Product information - BMW brake pads | HELLA

BMW brake pads

8DB 355 012-321 / 8DB 355 015-601

Changed brake pads

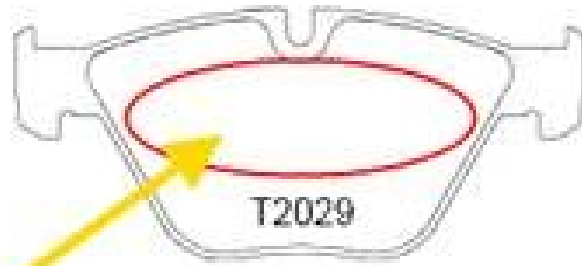
Brake pad 8DB 355 012-321 / T1596 will be replaced by brake pad 8DB 355 015-601 / T2029.

The difference between both brake pads is the missing retaining spring (A) on the brake pad 8DB 355 015-601 / T2029 on the fist side. The missing retaining spring does not have any influence on the comfort conduct of the brake pad.
